Request for Comments (2nd Submission)

Case Name: Berkley Shores Final Development Plan (FDP), Final Plat and Waiver of Subdivision Standards
Case Number: PRC2019-00019

Level 3 – Storm Drainage Study Report

Berkley Shores

BERKLEY SHORES
 CIVIL CONSTRUCTION DOCUMENTS
DRAINAGE PLAN

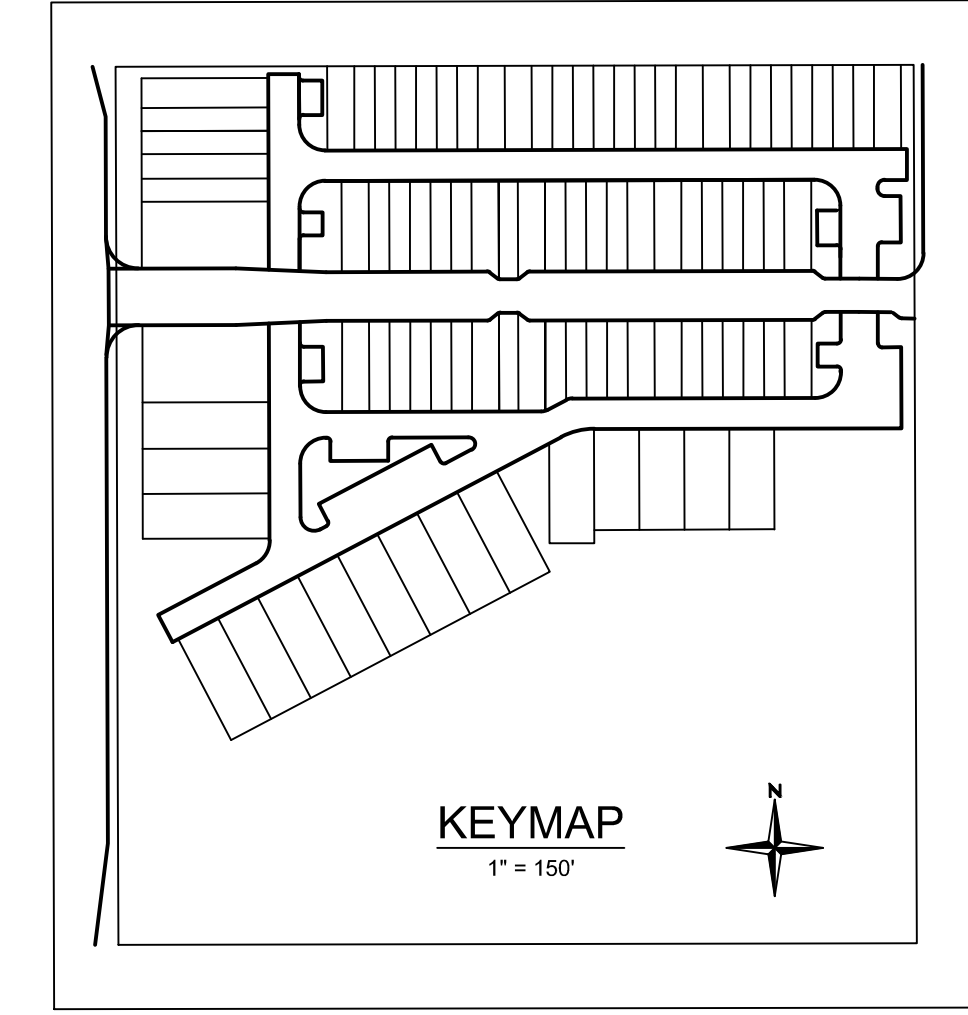
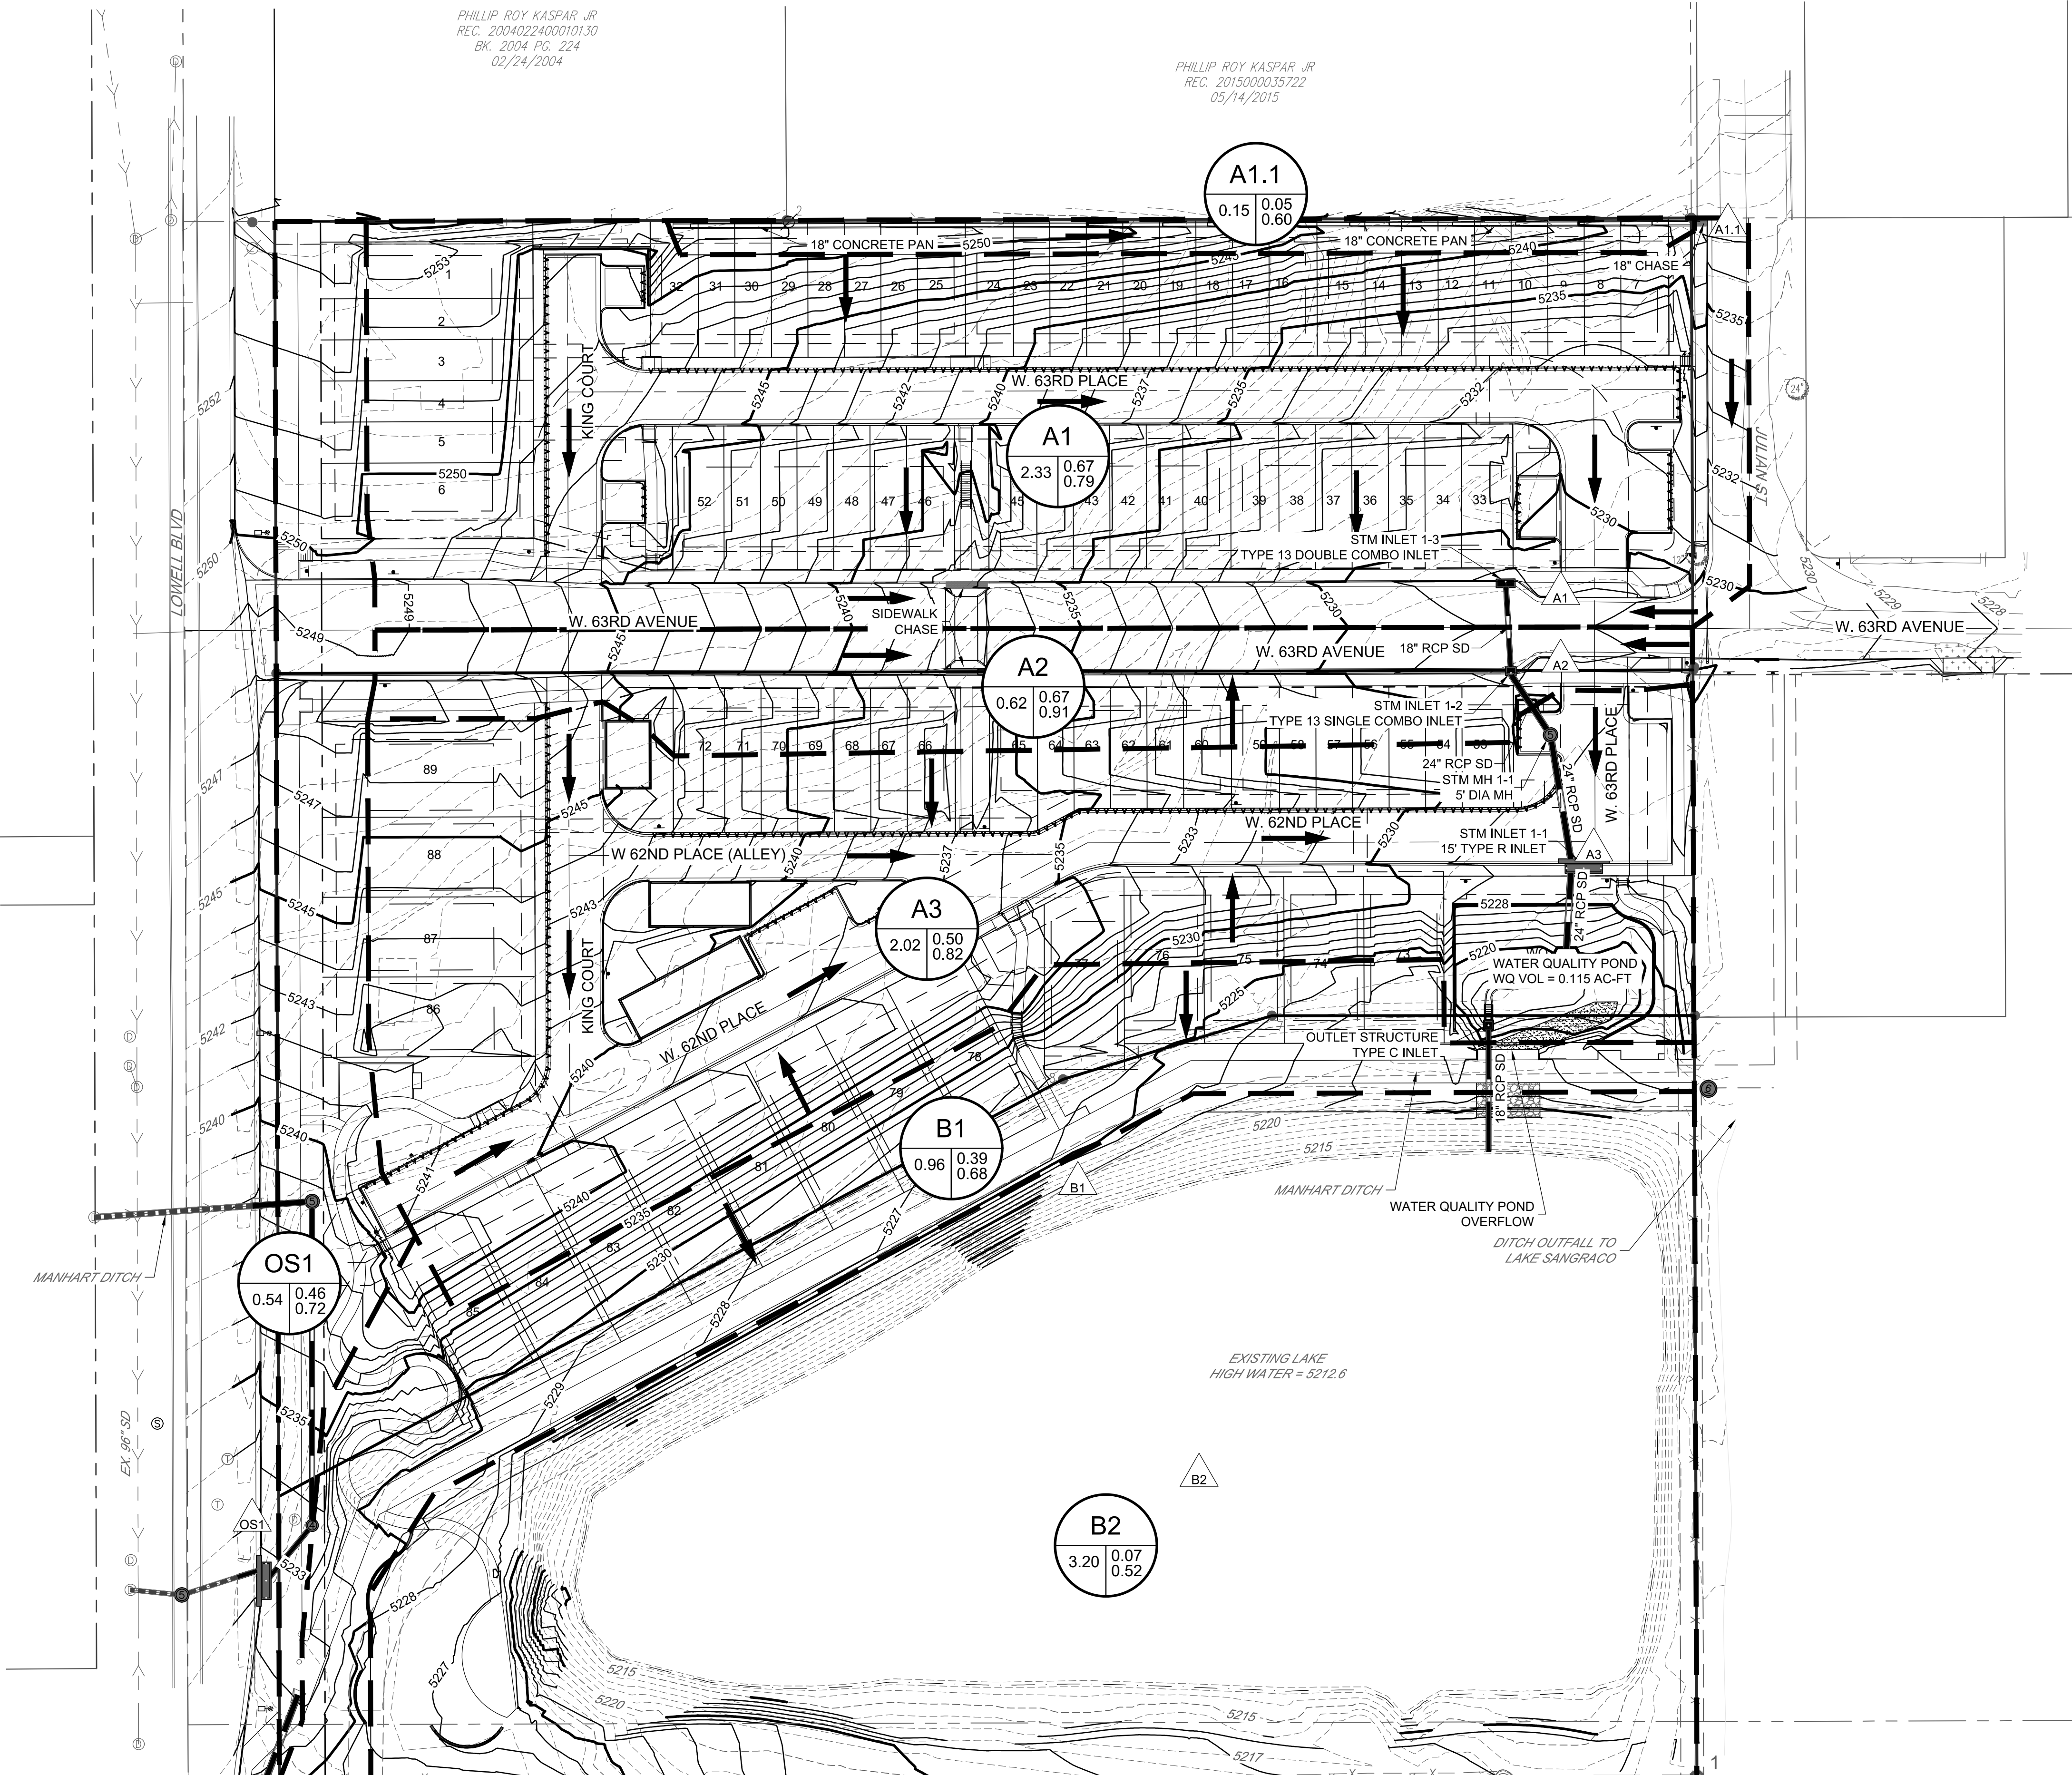
32	ME	Grading Plans	Add more labels to the existing contours.	Additional contour labels have been added.
33	ME	Drainage Report	The Drainage analysis needs to include all offsite basins. There is a significant area to the north of the site that drains to the north-east corner of the site. This area needs to be included in the drainage analysis and mitigated for.	There are currently additional offsite investigations regarding the existing storm system adjacent to the site. Once the information is available, it will be incorporated into the drainage report.
34	ME	Drainage Report/Plans	There is an existing storm sewer that is located along the west edge of Julian St and, appears to enter the Berkeley Shores property south of the intersection of Julian St and W 63 rd Ave. This storm sewer needs to be shown in the construction plans and, if it does enter the property, connected to the proposed storm sewer outfall for this development.	There are currently additional offsite investigations regarding the existing storm system adjacent to the site. Once the information is available, it will be incorporated into the drainage report.
